Report: FINAL REPORT
Function: Test, Adjust, & Balance
Date: 11/01/2022

10-24 WALGREENS #03606 - SARASOTA,FL

Project: 10-24 WALGREENS #03606 - SARASOTA,FL

Issue Name : No OCP Wires Landed

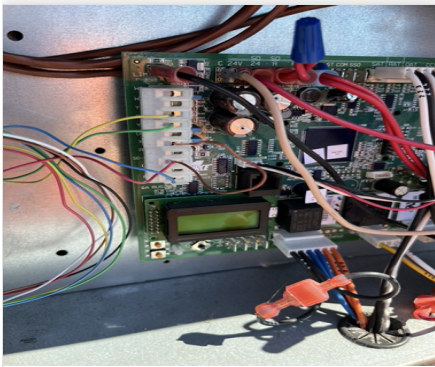
Description : There are no OCP wires landed in the new RTUs. NTAB installed jumpers in order to complete balance.

- **11/01/2022 National TAB - Will Turnbough**
 - Acceptable per Startup binder
